PROJECT REVIEW COMMITTEE - CITY OF WILDWOOD

Agenda
Regular Meeting
June 11, 2024 10:00 AM
Commission Conference Room 124
100 N Main Street

3. **SP 2208-010 Inspire Parkview Independent Senior Community - Liberty
Senior Center
Parcel G08-016**

The applicant is seeking a favorable recommendation from the Project Review Committee for the construction of a 167,118 SF independent living facility consisting of 164 units with associated infrastructure, per the attached plans.

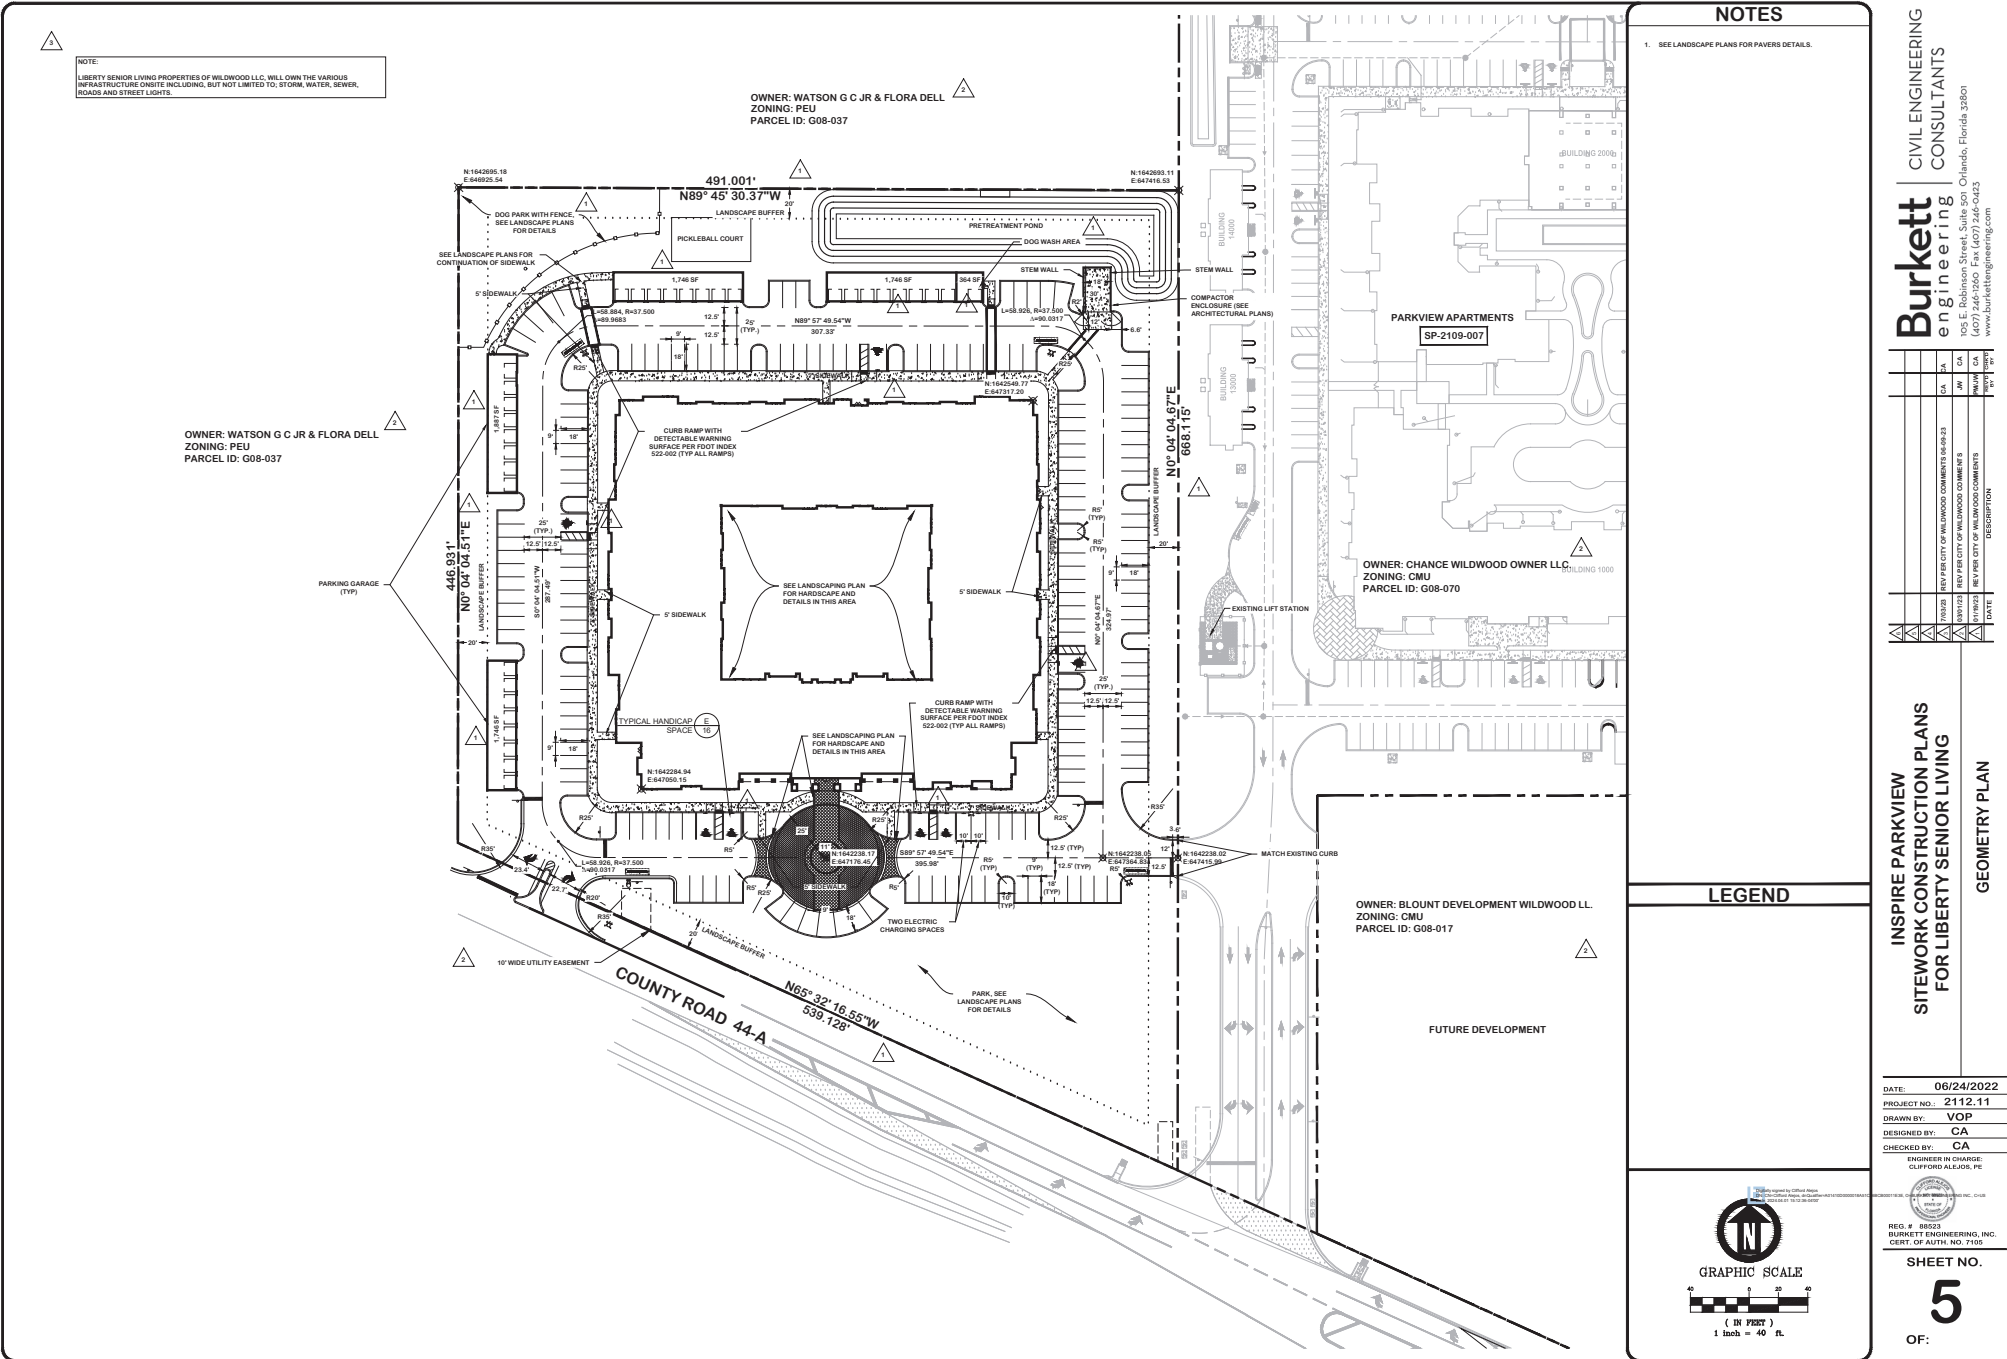
1. LDR 4.4(C)(7) – Provide copy of cross-access easement for east driveway connection to current and future related development.

2. LDR 4.4(C)(8) – Provide copy of easement for sanitary sewer connection to adjacent private parcel as shown on Sheet 7.

3. LDR 4.4(C)(7) – Provide copy of easement for stormwater system connection to adjacent private parcel as shown on Sheet 8.

- i. Response: As discussed with Amanda Bondi, the copy of the cross-access easement issuance will be deferred to a later time, due to the adjacent construction in the tri-party agreement, as as-builts will need to be provided to finalize the easement.

- i. Response: As discussed with Amanda Bondi, the copy of the sanitary sewer connection easement issuance will be deferred to a later time, due to the adjacent construction in the tri-party agreement, as as-builts will need to be provided to finalize the easement.

- i. Response: As discussed with Amanda Bondi, the copy of the stormwater system connection easement issuance will be deferred to a later time, due to the adjacent construction in the tri-party agreement, as as-builts will need to be provided to finalize the easement

Sheet Number:
 LT-00

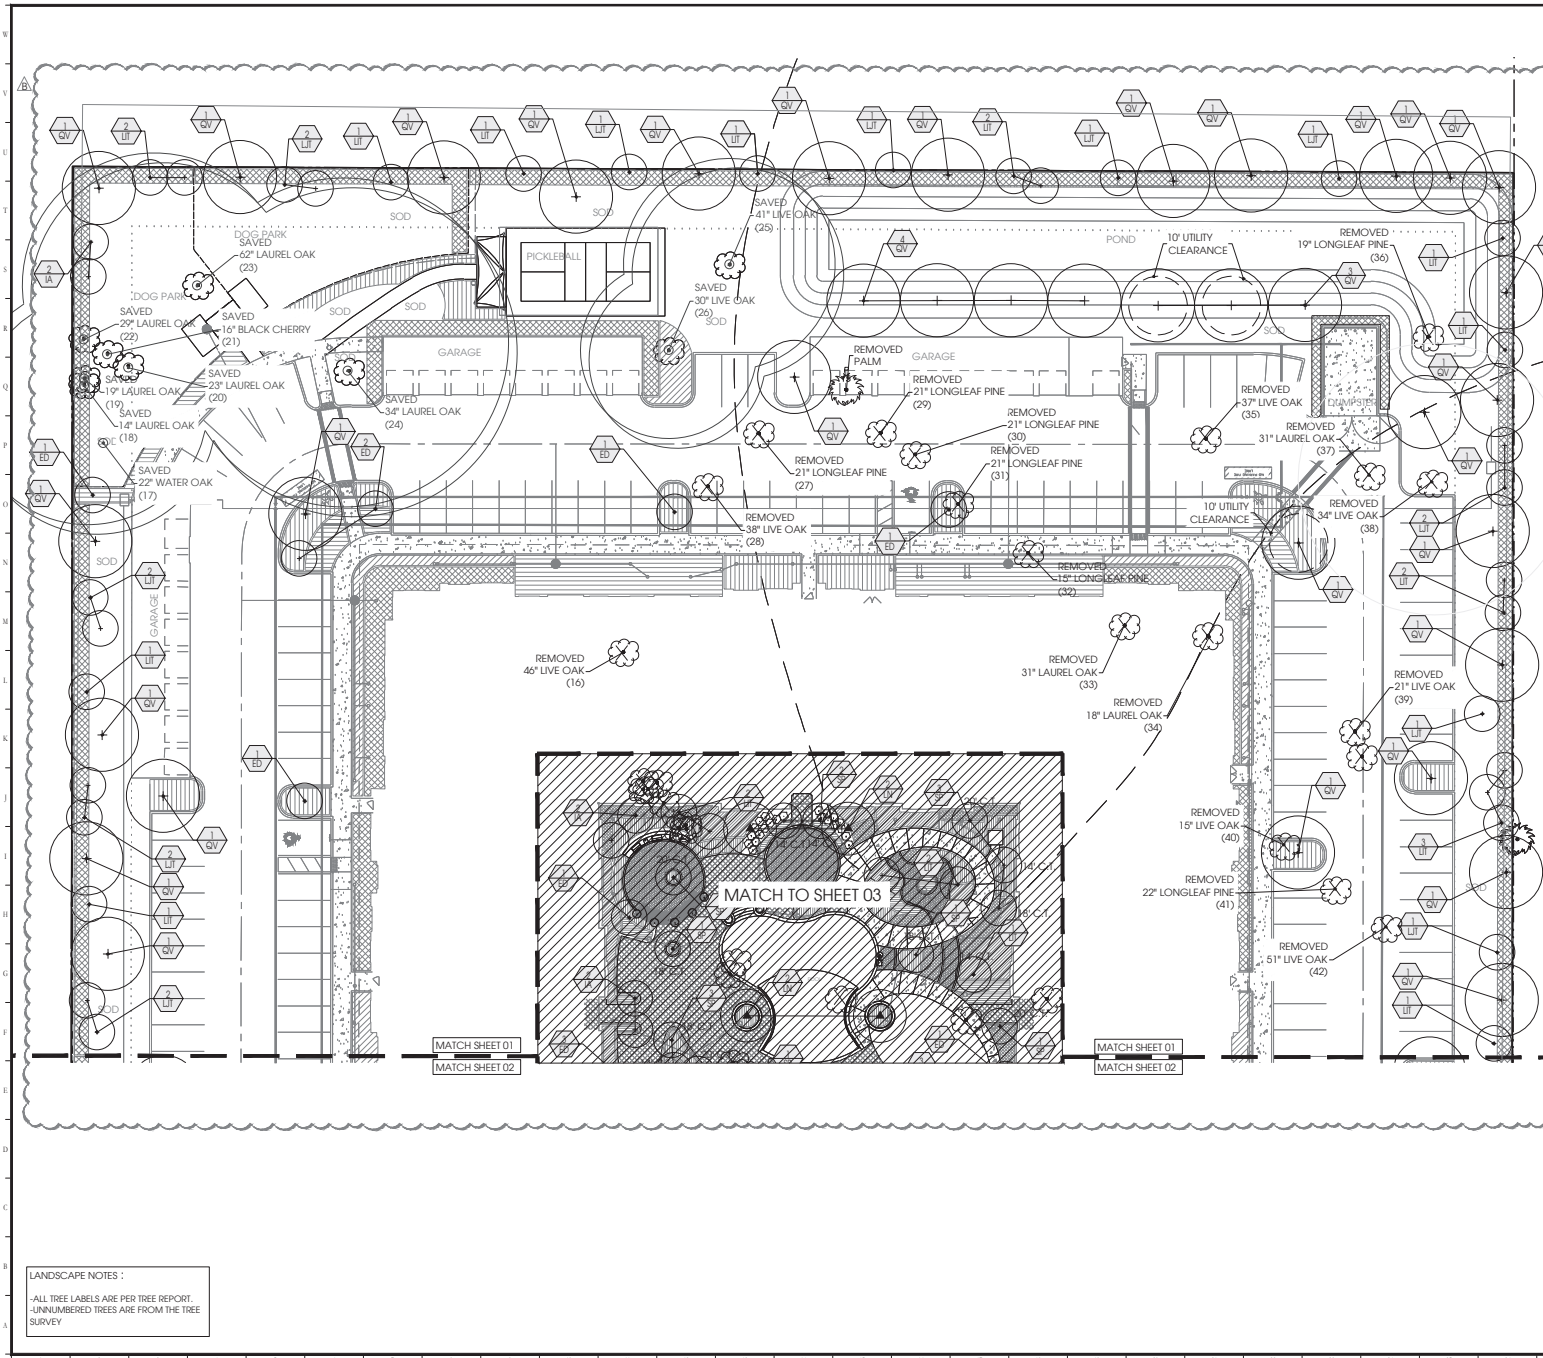
1. Show location of existing sewer line in the right of way on CR 44A to assure a minimum of 10' separation from all root baring trees
